1989 - 1991 Corvette: Service Bulletin: No/Delayed Reverse When Cold

Subject: NO/DELAYED REVERSE WHEN COLD INSTALL REV.
INPUT CLUTCH SEAL

Bulletin Number: 91-493-7A - (03/11/1992)

SUBJECT: ----- No Reverse/Delayed Reverse Cold (Install Long Lipped Reverse Input Clutch Piston Outer Seal)

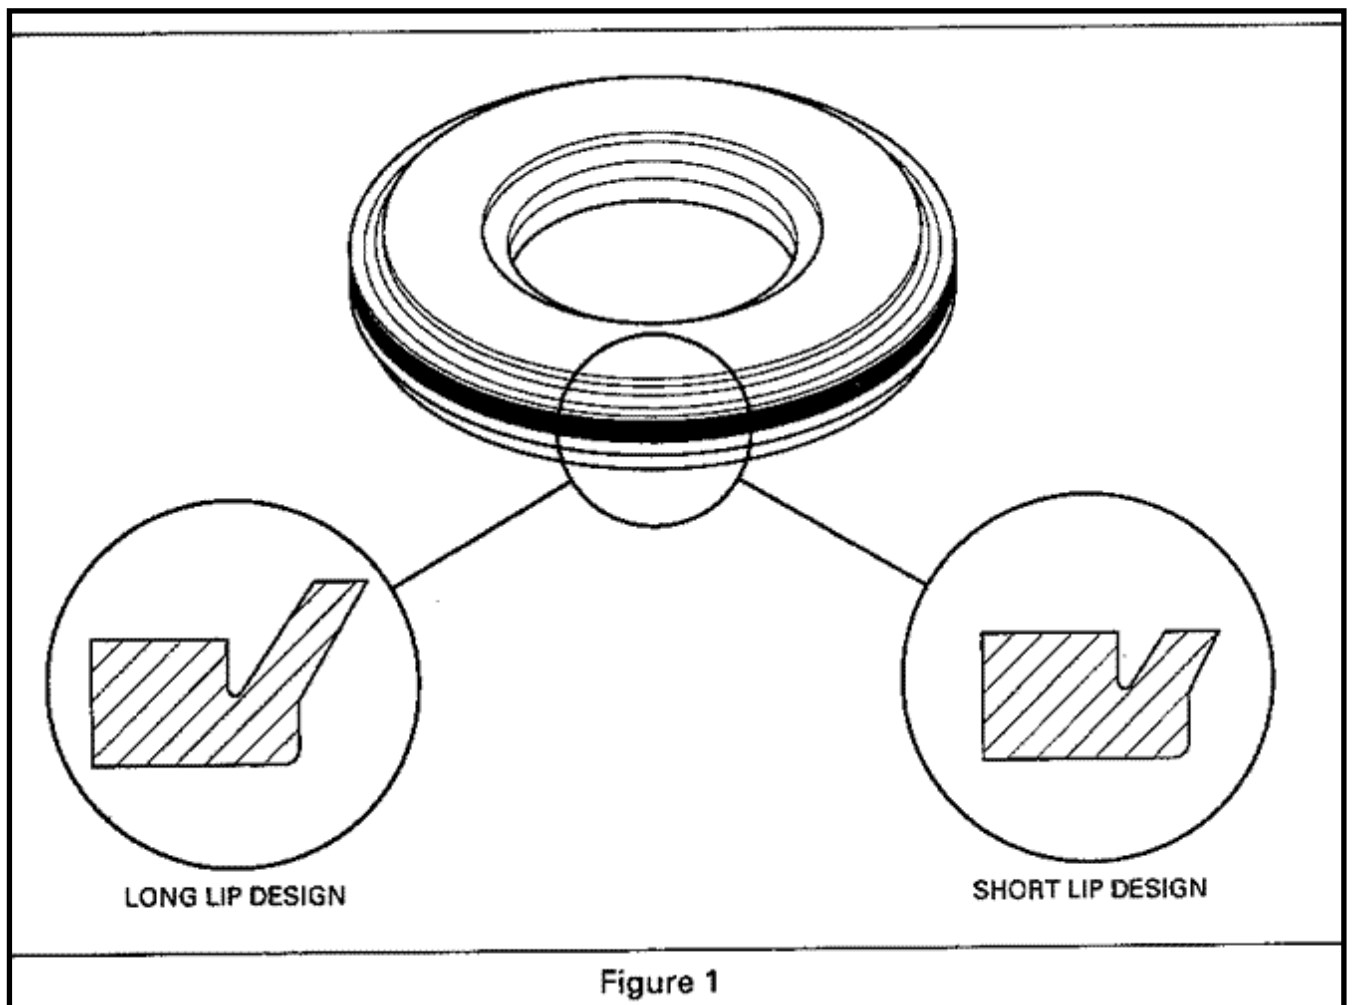
If a transmission has a 'no reverse' or 'delayed reverse' condition, inspect the reverse input clutch piston outer seal. Determine if the seal is a 'short lip' or 'long lip' design by comparing it to Figure 1. If it is a short lip design, replace it with a long lip seal contained in the service packages listed under Service Parts Information.

If the reverse input clutch piston outer seal is a long lip design, or the newly installed long lip seal doesn't alleviate the delayed reverse condition, the reverse input clutch housing may be out of round. Inspect the housing and replace if necessary.

The long lipped seals are available in several service packages. Description
Part Number
